Evaluation of the report of Tokyo Electric Power Company regarding the leakage from the RO concentrated water storage tank at the Fukushima Daiichi Nuclear Power Station

31 March 2015
Nuclear Regulation Authority, Japan

Evaluation of the report of Tokyo Electric Power Company regarding the leakage from the RO concentrated water storage tank at the Fukushima Daiichi Nuclear Power Station

10 December 2014
Nuclear Regulation Authority, Japan

Figure 7 Location of leakage^{*2}

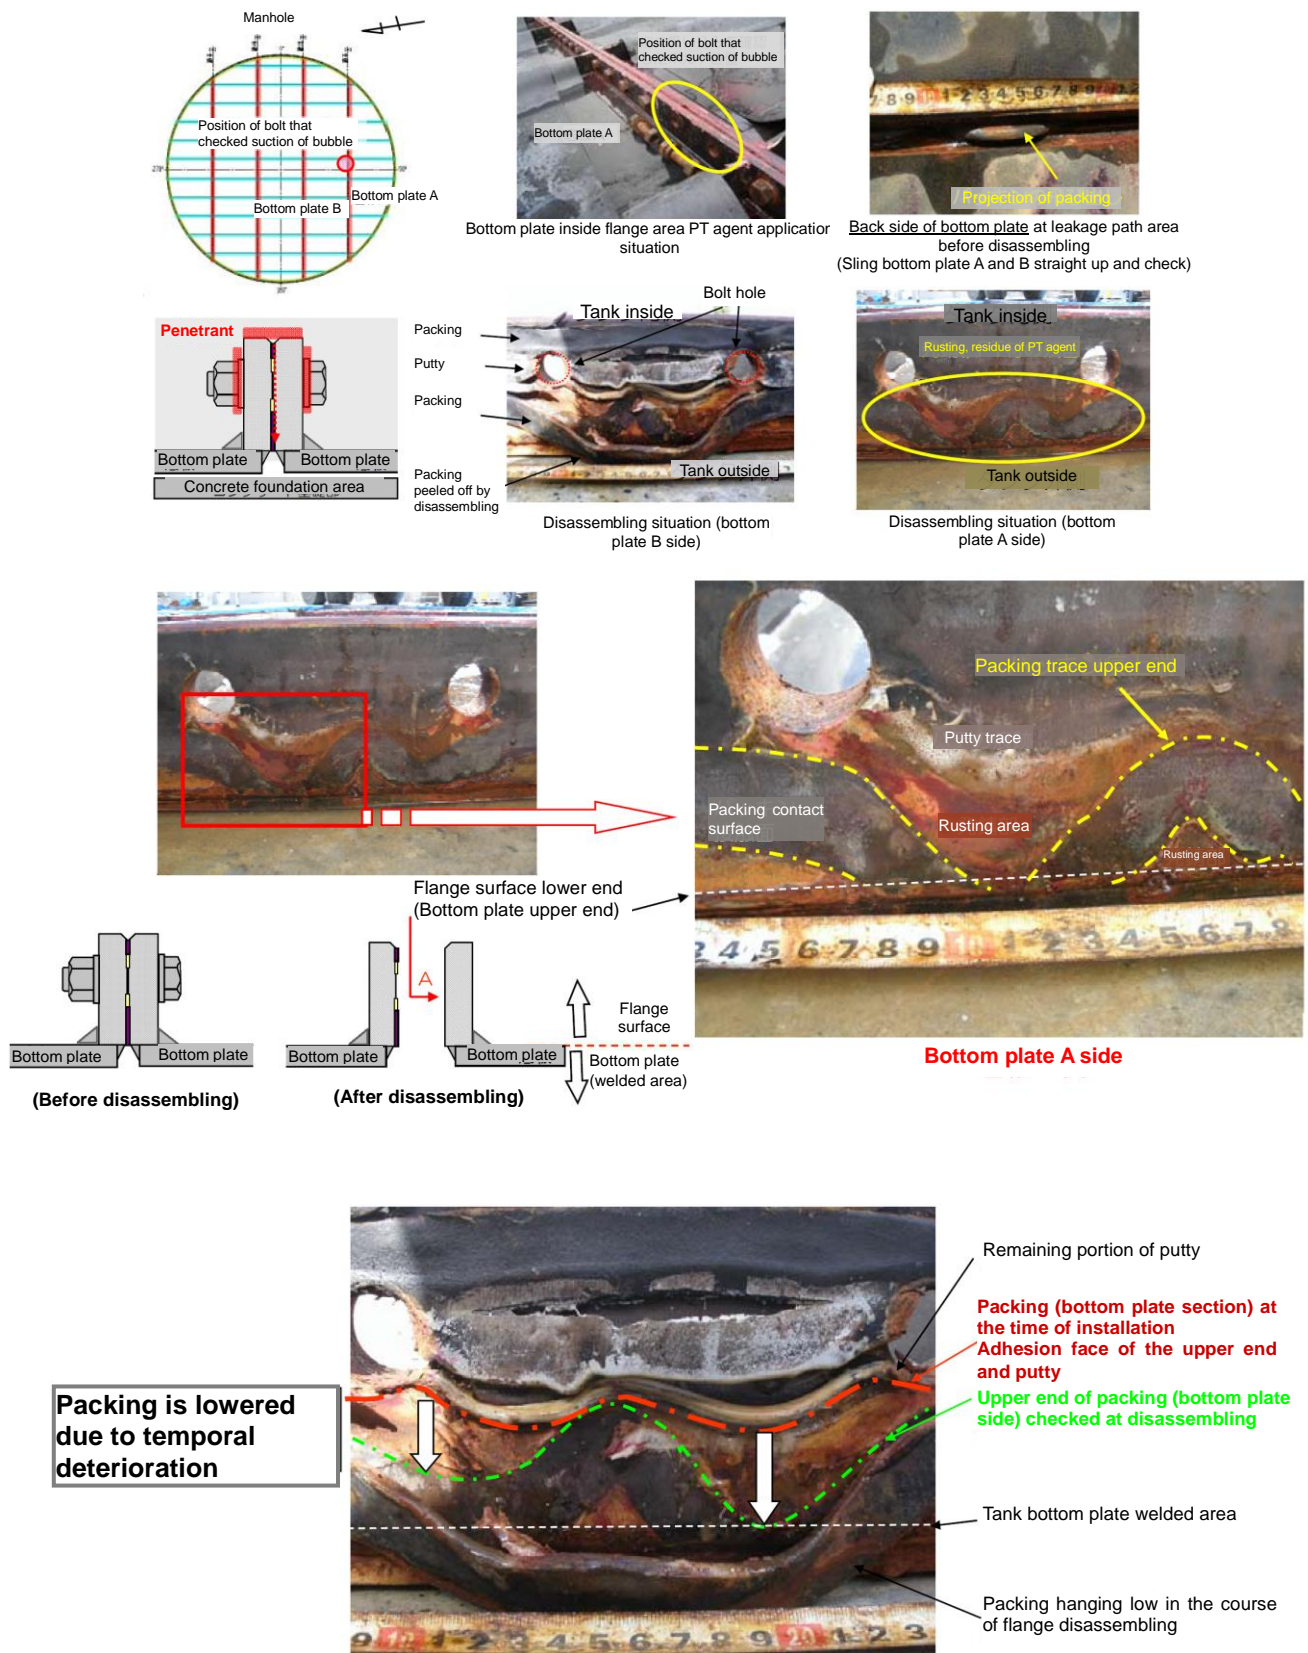
As a result, it was found that the leakage point was located at the discovered protrusion

of packing at the flange section of the tank bottom plate (refer to Figure 7). The assumed cause was estimated to be a reduction of bolt torque to tighten the packing, due to the impact of thermal expansion/shrinking of the flange caused by a subtle waving of the packing at the time of tightening the bolt at the location of the leakage. In addition, it was accompanied with the opening of the lower end of the flange. It is presumed that this led to the protrusion of the packing which shifted downward out of the bottom of the tank due to the inability to resist the water pressure of the tank.

Figure 8 Tentative countermeasures until replacing with welded tanks^{*2}

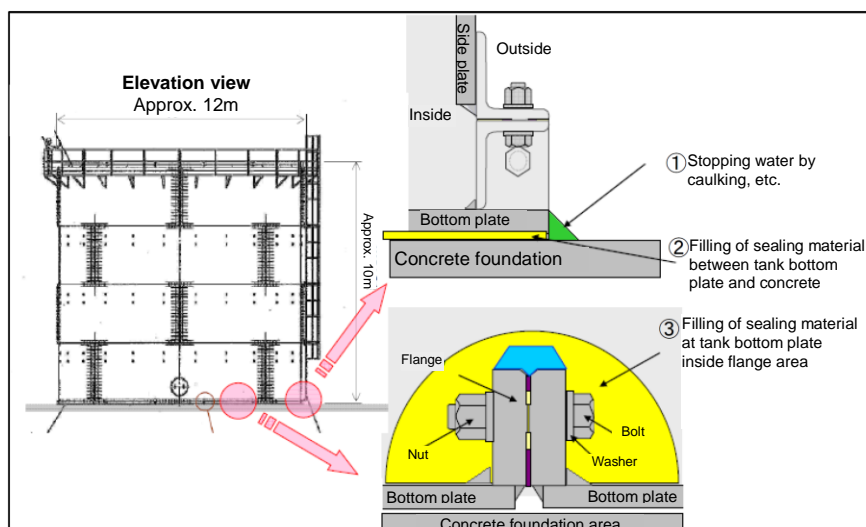
As tentative countermeasures until replacing with welded tanks, the implementation of following measures shall be considered (refer to Figure 8): 1) Waterproofing by caulking, etc. at the bottom of the tank, 2) Filling sealing material underneath the bottom plate, and 3) Filling sealing material at the bottom plate section (inside).

Figure 19 Future utilization principle of flange type tanks
(Extracted from the Secretariat of the NRA's document for a meeting with TEPCO)

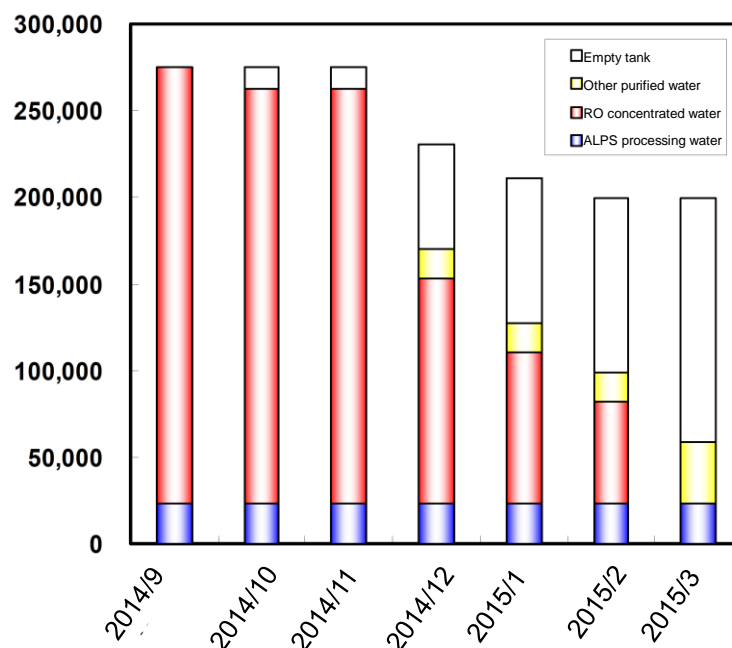
The Secretariat of the NRA has checked on the purification work and draining water by the purification system that are not described in the report in addition to replacing the tanks to welded tanks and tentative countermeasures in the Secretariat of the NRA's document for a meeting with TEPCO. It can be evaluated to have a certain level of effect for reducing risk of leakage since more than two countermeasures are implemented for both areas of tanks (refer to Table 4). Countermeasures summarized by TEPCO such as the replace measure of the flange type tank shall be checked about its implementation situation at an appropriate timing by safety inspection, etc. (refer to Figure 19).
